Access Compliance Report

Public Rights-of-Way

Intersection ID: 46758	Main Street: CUMBERLAND_COVE_DR	Cross Street: SUPERIOR_ST	Location: NW
ADA ID: 55B8F0352ED8	Ramp Type: PerpDiag	Initial Pass/Fail: Fail	Overall Compliance: No
Codes/Mitigation Info/Possible Solution		Field Measurements/Component Compliance

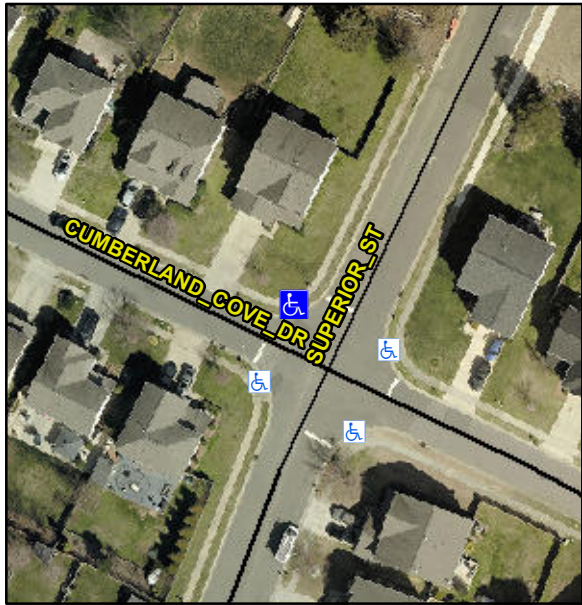
Possible Solutions:		Compliance		Description	Data	Compliance	Description	Data
	Remove & Replace Curb Ramp With Two New Directional Ramps or Equivalent.		N/A	Ramp Length (in)	47.0	No	Ramp Slope (%)	10.3	
			Yes	Ramp Width (in)	48.0	No	Ramp XSlope (%)	3.4	
			N/A	Flare Type LT	N/A	N/A	Flare Type RT	N/A	
			N/A	Flare Slope LT (%)	N/A	N/A	Flare Slope RT (%)	N/A	
			N/A	Flare Traversable LT?	N/A	N/A	Flare Traversable RT?	N/A	
			N/A	Landing Length (in)	N/A	N/A	DWS Provided?	N/A	
			N/A	Landing Width (in)	N/A	N/A	DWS Contrast?	N/A	
			N/A	Landing Slope (%)	N/A	N/A	DWS Length (in)	N/A	
			N/A	Landing X Slope (%)	N/A	N/A	DWS Full Width?	N/A	
Surveyor Notes:		N/A	N/A	Landing Curb? (Y/N)	N/A	N/A	DWS Offset (in)	N/A	
			N/A	Shared Landing?	N/A				
PROW/ADA:			N/A	Gutter Ponding?	N/A	N/A	Gutter Slope (%)	N/A	
			N/A	Gutter Lip Ht (in)	N/A	N/A	Gutter X Slope (%)	N/A	
			N/A	Painted X Walk1?	No	N/A	Painted X Walk2?	No

X Walk 1 Direction	To SW		X Walk 2 Direction	To SE	
			N/A	X Walk 1 Width (in)	N/A	N/A	X Walk 2 Width (in)	N/A	
				X Walk 1 Slope (%)	4.0		X Walk 2 Slope (%)	0.9	
				X Walk 1 X Slope (%)	2.4		X Walk 2 X Slope (%)	3.9	
			N/A	Ramp inside XWalk1?	N/A	N/A	Ramp inside XWalk2?	N/A	
				Road Slope (%)	2.9	N/A	Clear Space?	N/A	
				Road X Slope (%)	4.5	N/A	Clear Space to XWalk (in)	N/A	
			N/A	Any Obstructions?	N/A	N/A	Storm Grate/Utility Hazard?	N/A	
				Obstruction Type			Storm Grate/Utility Type		
					N/A			N/A	
						Yes	Surface Condition? (G/P)	Good
